Charlotte Historic District Commission

Agenda Supplement

1414 THE PLAZA RESIDENCE
CHARLOTTE, NC 28205

HDC STAFF COMMENTS & RESPONSES**STAFF COMMENTS:**

PROPOSED DOORS STUDY**DOOR STUDY - NEW GLASS DOORS ON
ADDITION AND PAVILION**

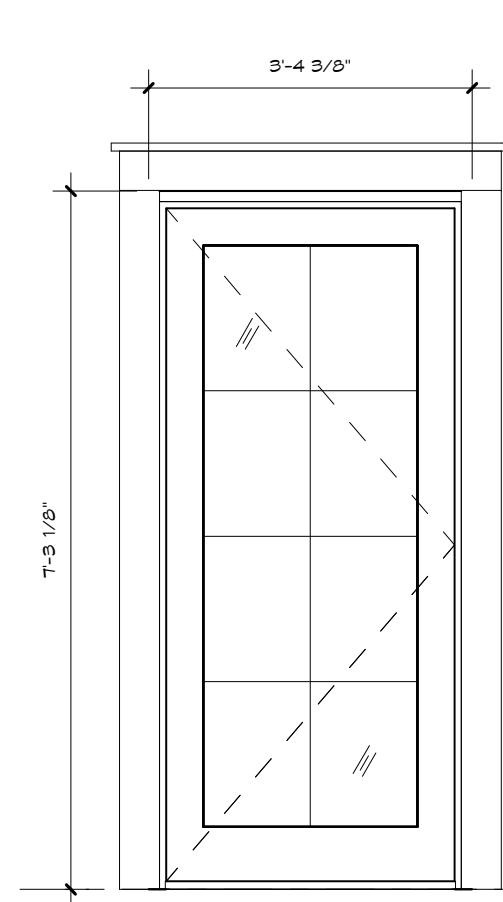
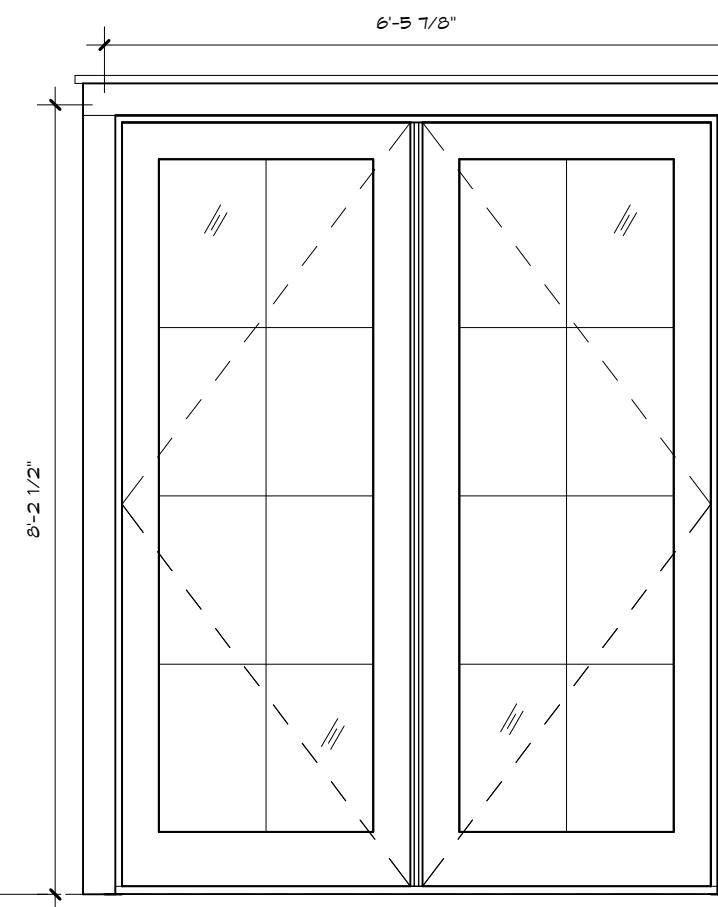
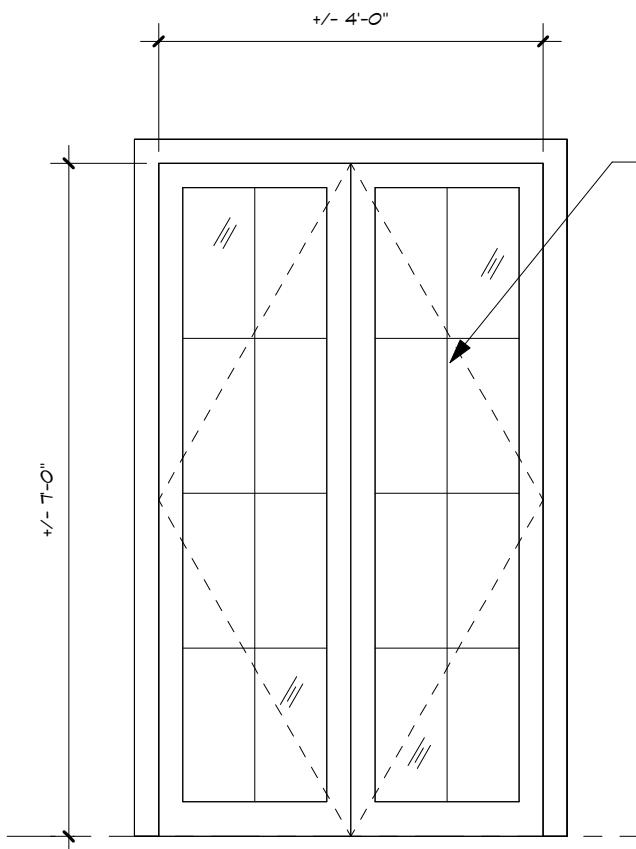
- c. Door details, dimensions, and materials needed.

- d. Door details, dimensions, and materials needed.

Refer to details, dimensions, and proposed specification information on page 5-7, & 9-12.

Refer to door details, dimensions, and proposed specification information on page 5-7, & 9-12.

ADDITIONAL PRODUCT CUT SHEETS - WOOD GARAGE DOOR

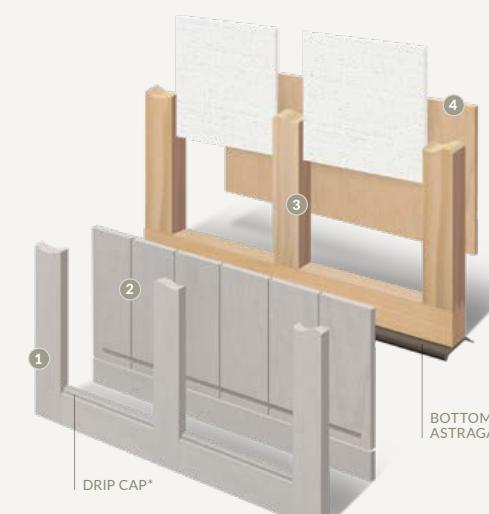
- b. Garage doors should be wood; specifications needed.

Garage doors proposed to be: Clopay Reserve Wood Extira. Refer to garage specification information on page 13.

AQUALINE™

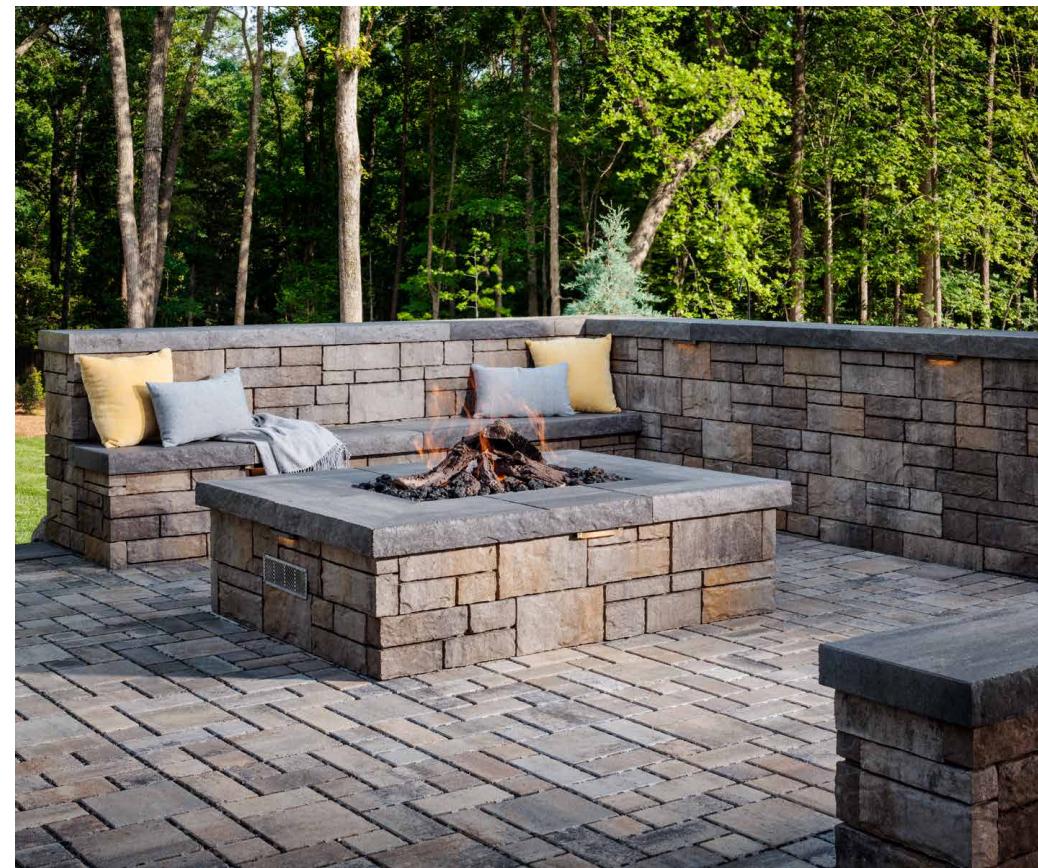
- a. Driveway material noted as pavers; specifications needed.

Wheel tracks are proposed to be permeable pavers: Belgrad - Aqualine Series. Refer to specification information on page 15.

ADDITIONAL PRODUCT CUT SHEETS - NEW METAL FENCE (INTERNAL YARD)

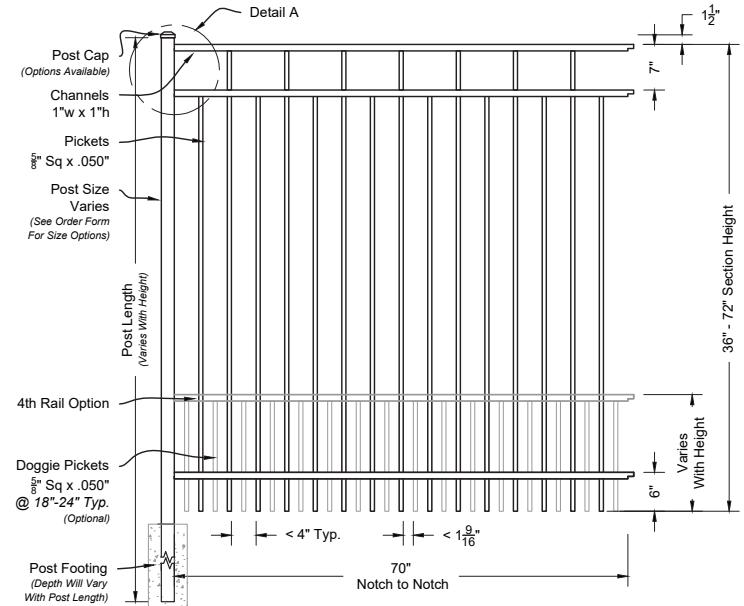
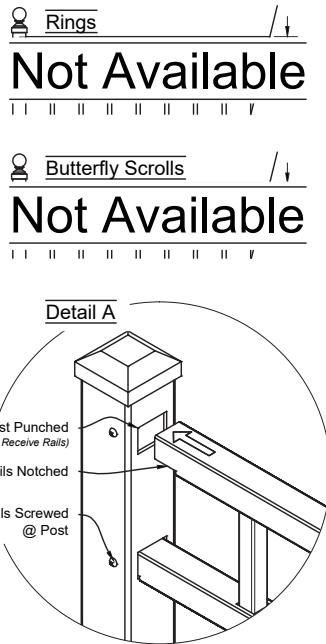
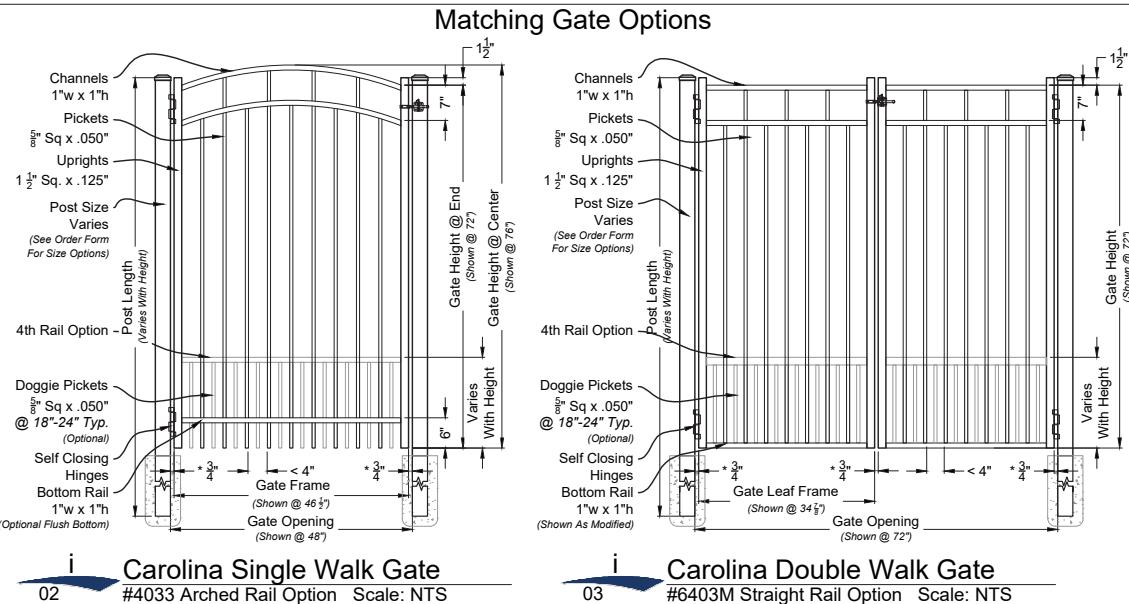
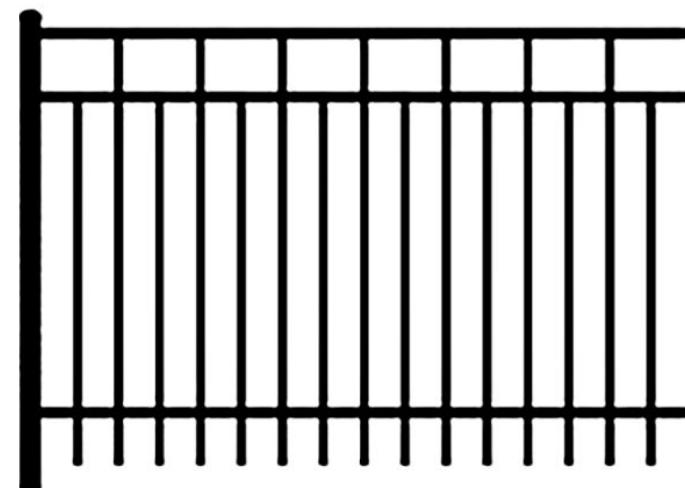
- d. Fencing and gate details, dimensions, and materials needed.

Refer to proposed gate specification information on page 16.
